UNITED STATES PATENT AND TRADEMARK OFFICE

APPLICATION NO.	FILING DATE	FIRST NAMED INVENTOR	ATTORNEY DOCKET NO.	CONFIRMATION NO.
10/041,599	01/10/2002	Nick Chen	CHEN-336	5101
1444	7590	06/02/2004	EXAMINER	
BROWDY AND NEIMARK, P.L.L.C. 624 NINTH STREET, NW SUITE 300 WASHINGTON, DC 20001-5303			HAMILTON, ISAAC N	
			ART UNIT	PAPER NUMBER
			3724

Office Action Summary	Application No. 10/041,599	Applicant(s) CHEN, NICK	
	Examiner Isaac N Hamilton	Art Unit 3724

Diagram 1: Figure 1 in Huang-Mo.

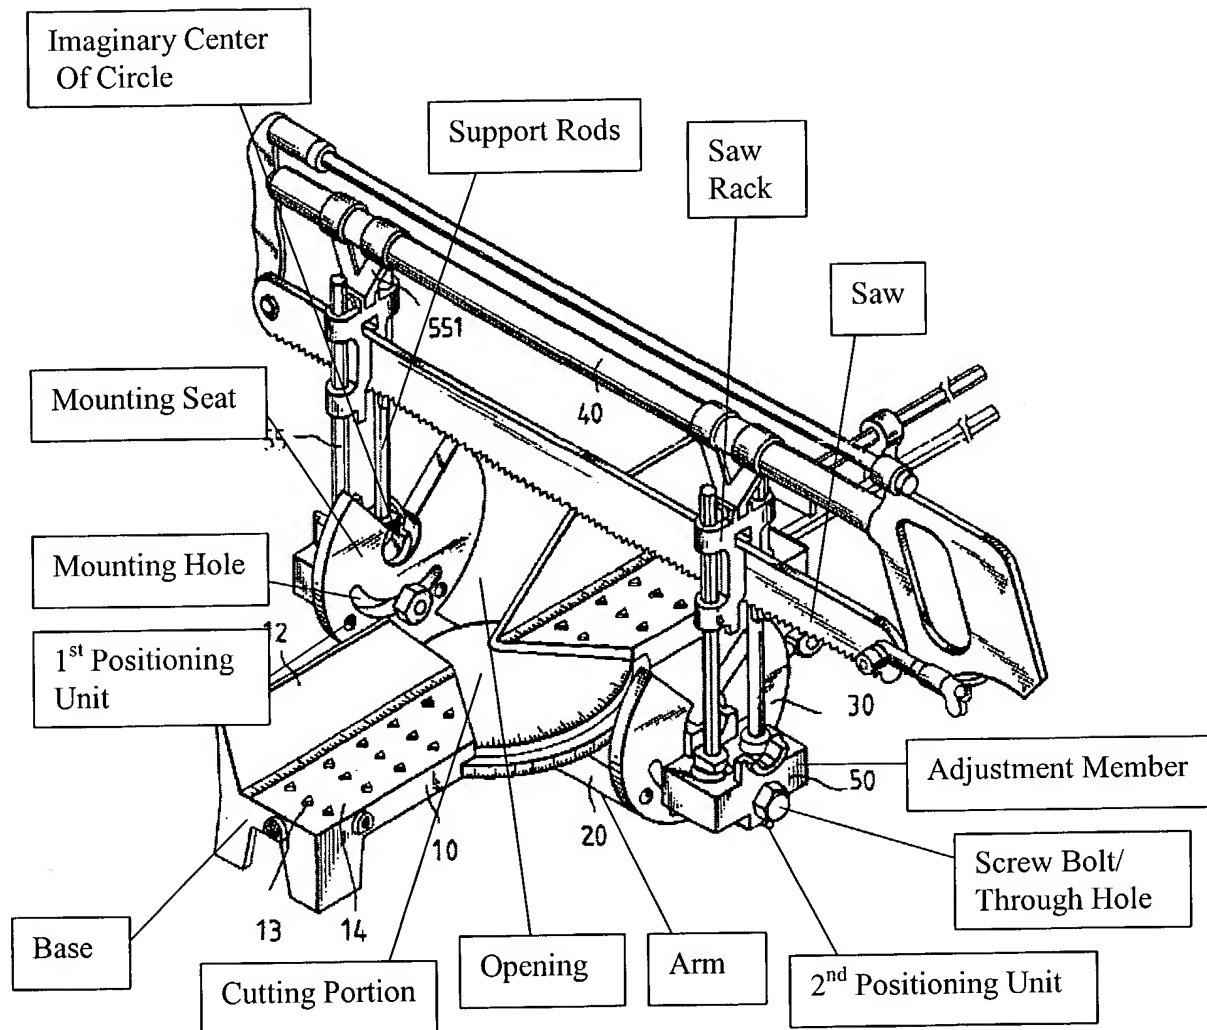
2. Claim 1 is rejected under 35 U.S.C. 102(b) as being anticipated by Huang-Mo et al (5,605,086), hereafter Huang-Mo. Huang-Mo discloses everything as noted below in Diagram 1 except for free rotation of the suspension arm, which is disclosed in column 2, line 5. Retaining portion and coupling portion are inherent due to column 2, lines 10-15, which disclose that arm 20 is releasably secured in place. See diagram below:

4. Claims 2-5 are rejected under 35 U.S.C. 103(a) as being unpatentable over Huang-Mo in view of Wang (5,392,679). Huang-Mo discloses everything as noted above, but does not disclose slots and does not disclose a locating rib. However, Huang-Mo teaches slots 33 and locating rib 43. It would have been obvious to provide slots and a locating rib in Huang-Mo as taught by Wang in order to provide a greater surface area between the first and second positioning units, which increases stability. Regarding claims 4 and 5, the mounting hole in Huang-Mo is arched. Note that the imaginary center of circle of the mounting hole and slots is labeled in Diagram 1.
